# CORRIGENDUM – MARCH 2021

During an internal review, including discussions with a third party, of the recently published Liquefied Petroleum Gas Safety On Site Guide (ISBN: 1-978-183863-006-5), NICEIC Certification believes it necessary to make you aware of a number of corrections addressing two specific points:

**Fig 12.6** Method 2 (overall provision using trickle ventilation at high level)

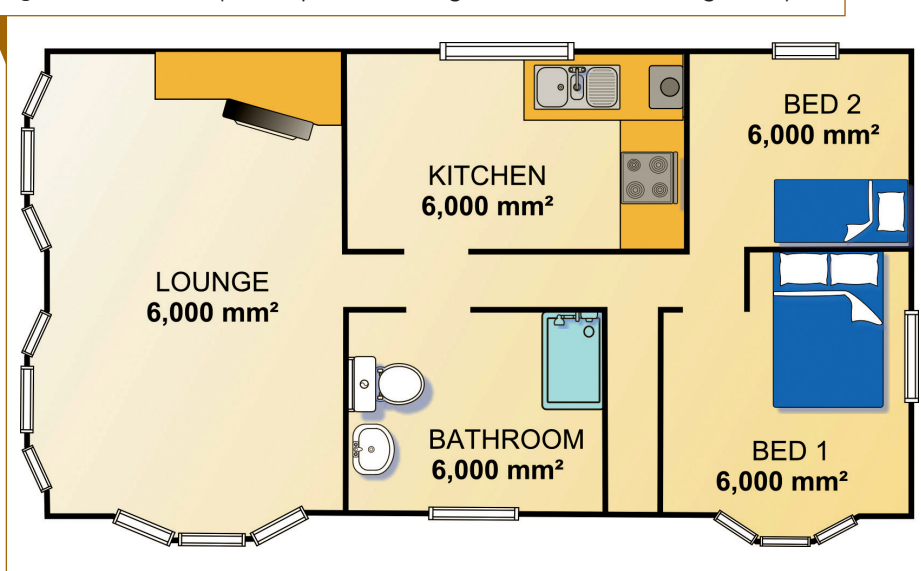
- page 12.8, fig 12.6 is incorrect as it is a duplication of fig 12.5 (fig shown last in this Corrigendum).
